**Manor 3364-2F**

## ATTACHMENT 1 VARIANCE REQUEST FORM

### Variance Request Form

**Variance Description:** Install condenser on balcony stucco wall

## ELEVATION PLAN – HVAC OUTDOOR UNIT LOCATION

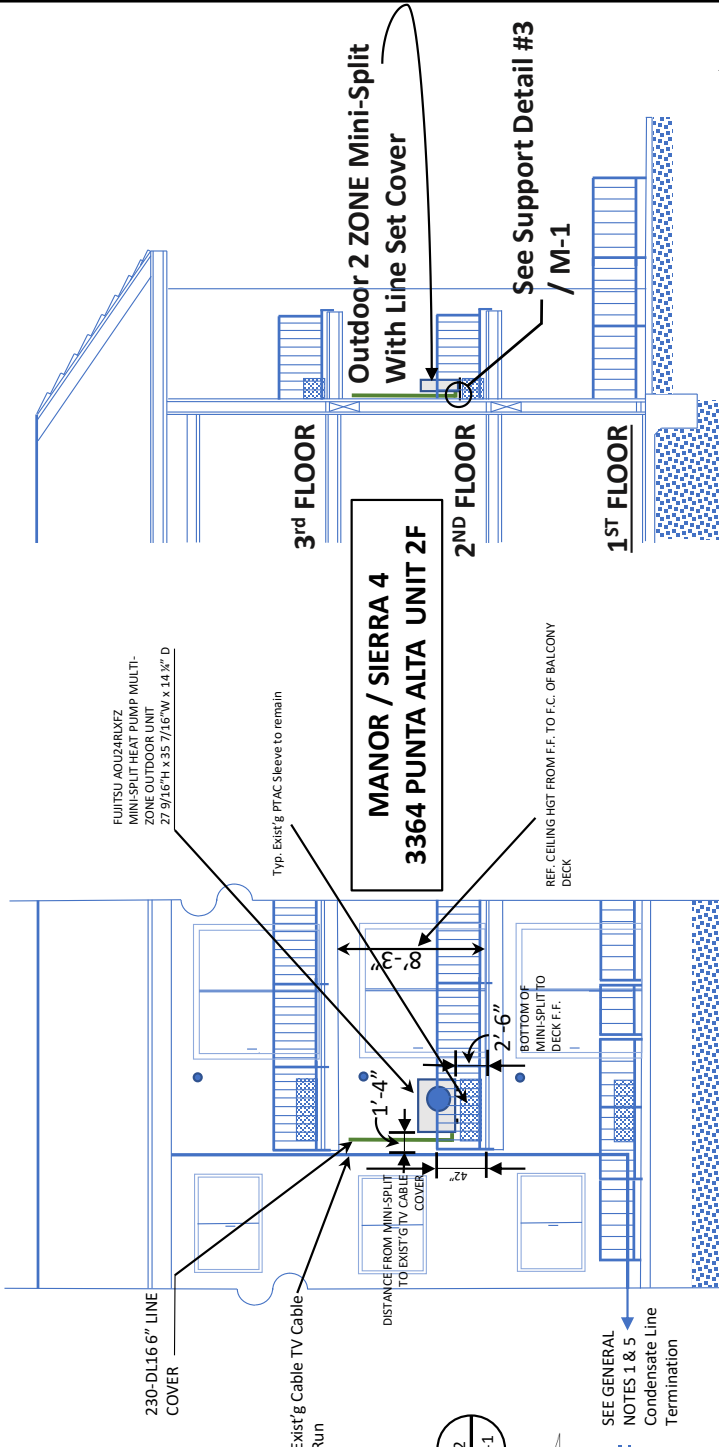
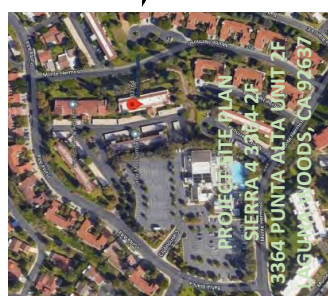
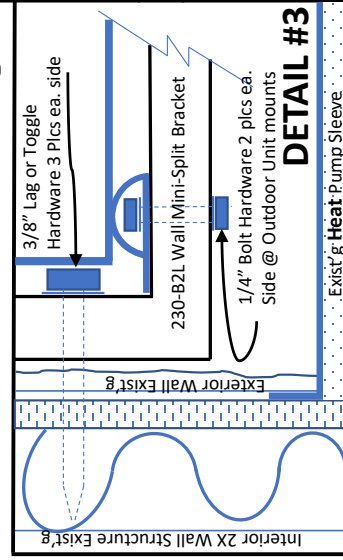
- A.1. The member shall install a condenser that is close in color to the existing building color, not white.
- A.2. The member shall install the condenser as per Standard 4 and properly redirect water drainage to avoid spillage to the downstairs manor.
- A.3. The Member shall install modesty panel to the balcony railing as per Standard 19 to conceal the condenser from the ground level.
- A.4. The Member shall provide plans, specifications, and calculations from a duly licensed architect or structural engineer to conform to the Building Code for all foundation, framing, and beam additions for the work of this variance.
- A.5. A City of Laguna Woods Building Permit will be required and provided to Manor Alterations to verify all code requirements for new or modified structural components, and shoring have been satisfied.
